**Analysis and Findings for
Hedges D (AR 19-0010)
February 27, 2020**

Case #:	AR 19-0010
Project:	Hedges D
Location:	11507 SW Amu Street. Tax ID 2S127BA Lots 800 and 900.
Applicant:	Mac Martin; Martin Development and Hedges D, an LLC
Owner:	Hedges D, an LLC

Figure 3: Site Plan (overview)

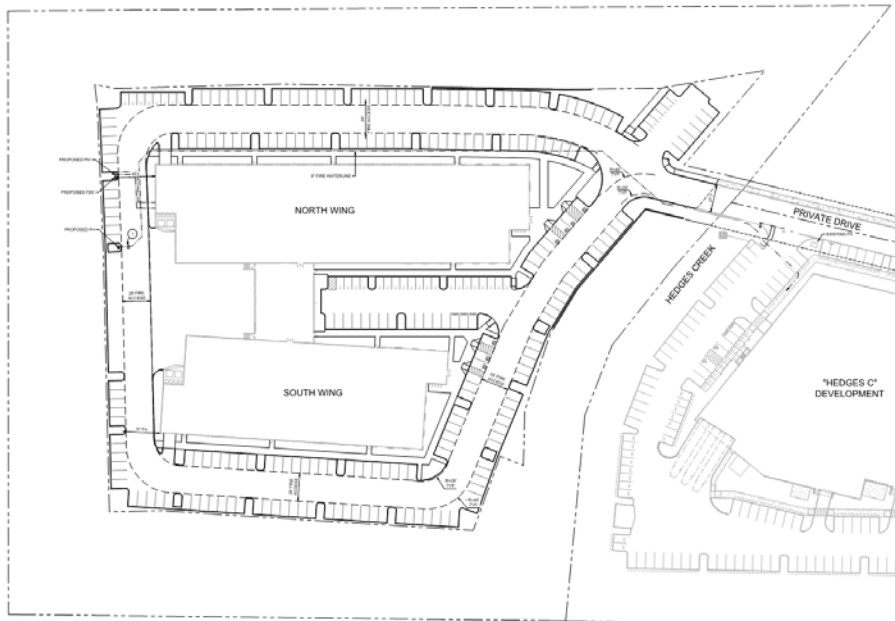
- c. A revised site plan with provision for 14 bicycle parking spaces pursuant to TDC 73C.100, and demonstrating compliance with the standards of TDC 73C.050.
- A7. The applicant must obtain Erosion Control, Water Quality, and Public Works Permits from the City of Tualatin.
- A8. The applicant must financially secure all public improvements in accordance with PWCC 102.14.00.

As shown on Site Plan A1.1, 8 outdoor bicycle parking spaces are proposed at the north and south wing entrances whereas 14 spaces are required in relationship to the proposed mix of uses as specified by TDC
